Planning and Zoning Commission

April 2, 2019

**3401 SE Destination Drive Site Plan
Lot 3 & 4 – Crossroads Business Park of Grimes Plat 4
Grimes, IA 50111**

FOX Engineering has completed the second review of 3401 SE Destination Drive Site Plan dated March 27, 2019. Please address the following comments:

**SOUTH BUILDING
ELEVATION**
(80% BRICK & 20% METAL)

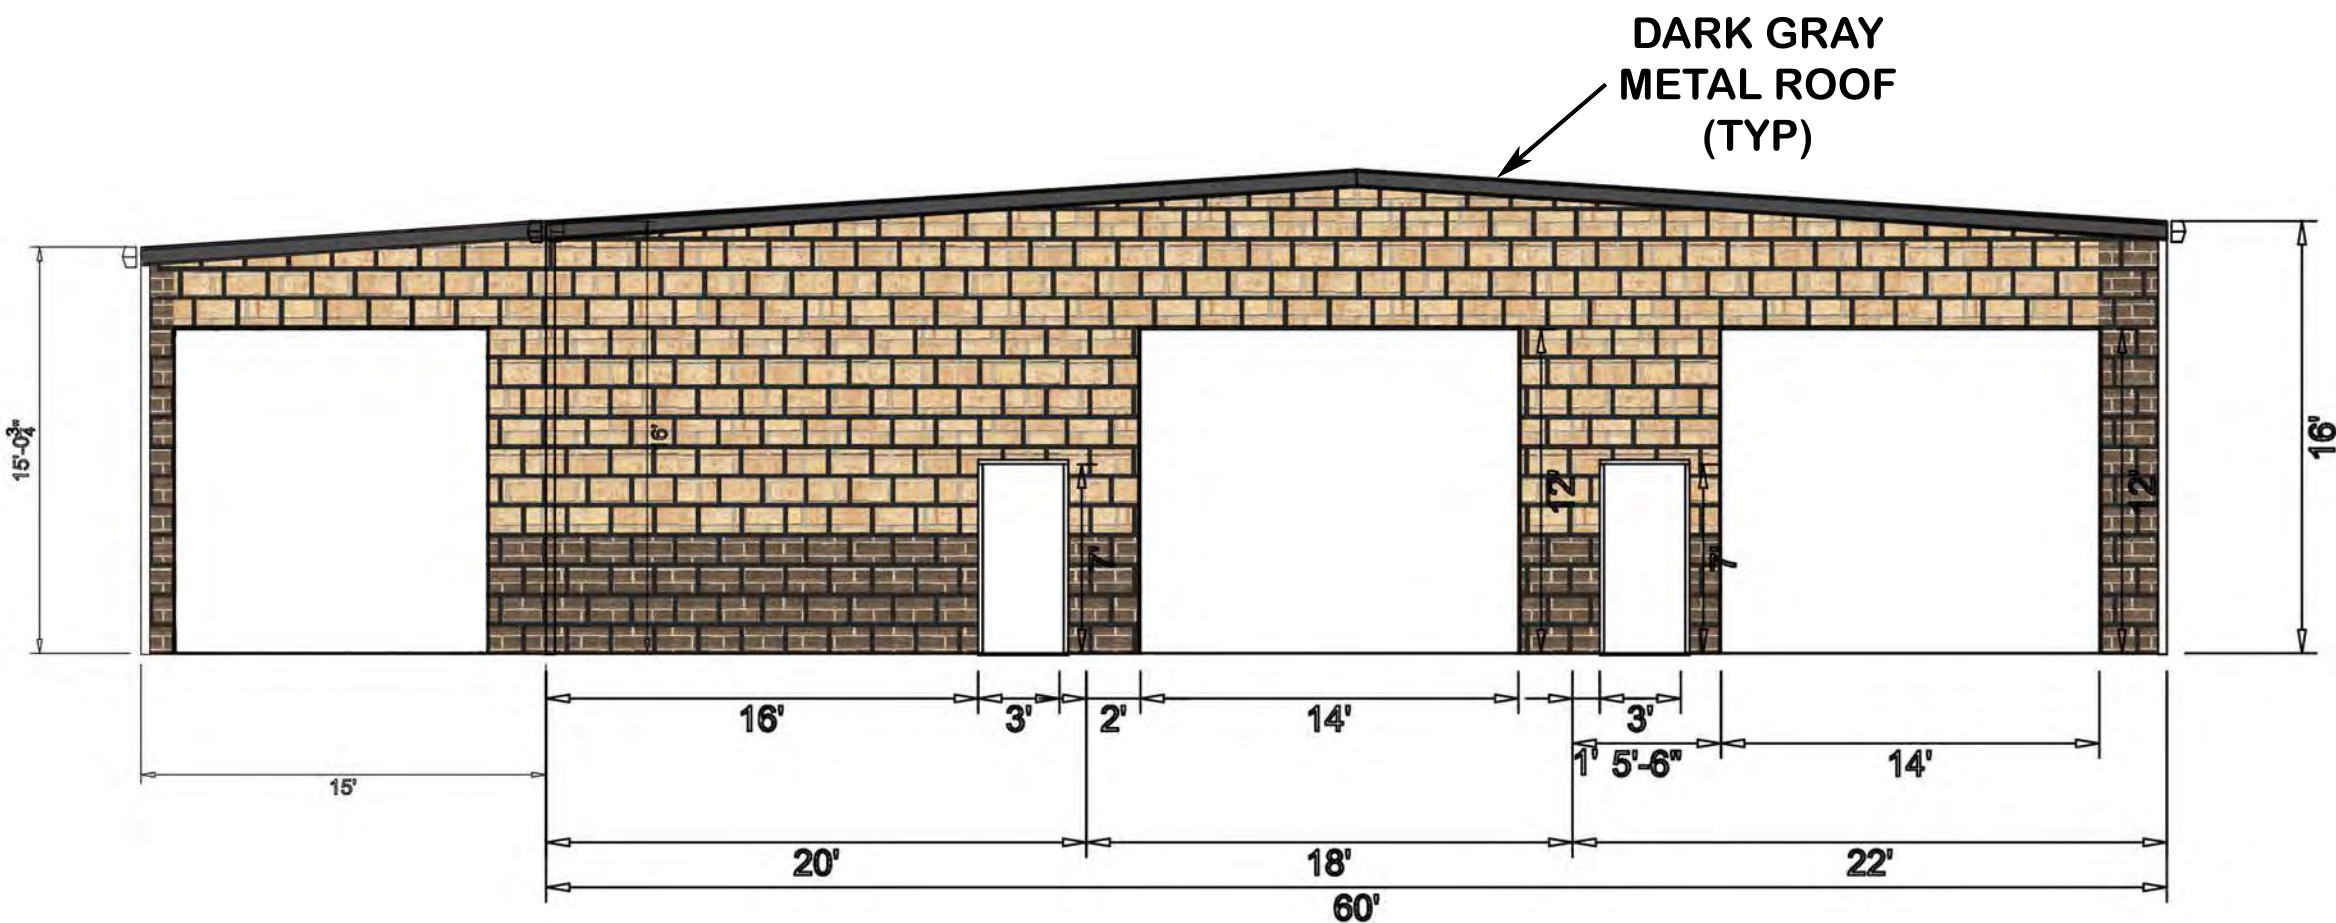
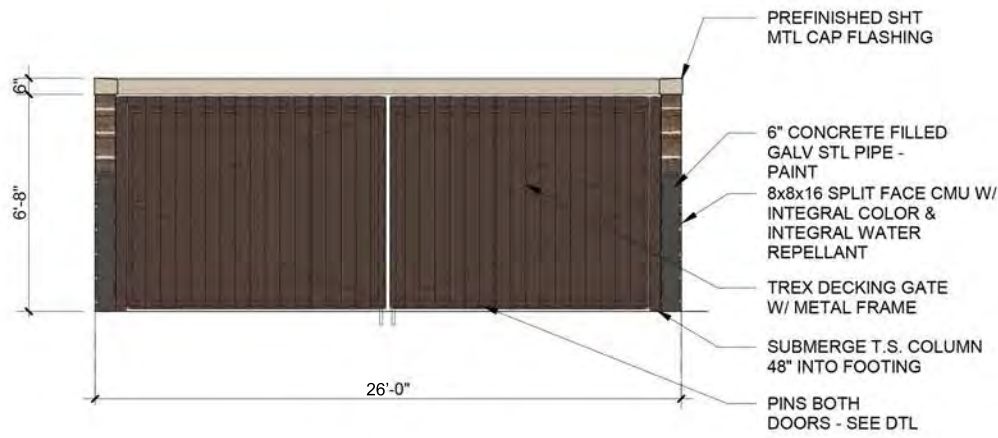
21. Please revise the south and north building elevation brick calculations to clarify what the percentage of brick is provided in the western 30-ft of the building (accounting for doors and windows). Grimes code requires that a minimum of 30-ft along the side walls that are adjacent to public street fronting walls shall be comprised of no less than 25% earth-tone colored brick, marble, etc...
